FA SERIES SOLENOID VALVE REPLACEMENT

Valve Kit 35TK4631A Solenoid with Fittings
(replaces 35T38279)

IN06-03 Printed in the U.S.A.
© Muncie Power Products, Inc. 2006

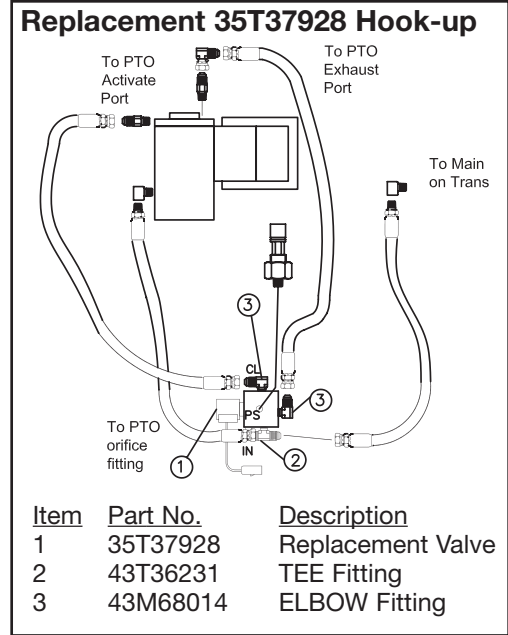
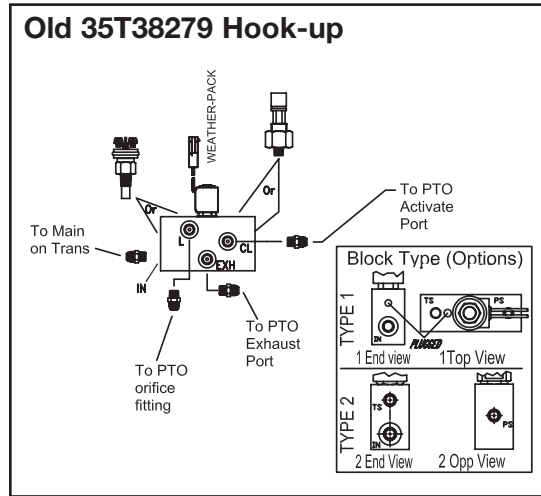
When replacing 35T38279 solenoid valve with 35T37928, follow the diagram to the right.

The 35T37928 valve does not have access for the temperature sender, but the sender is no longer a requirement of the Muncie or Ford system and can be disconnected.
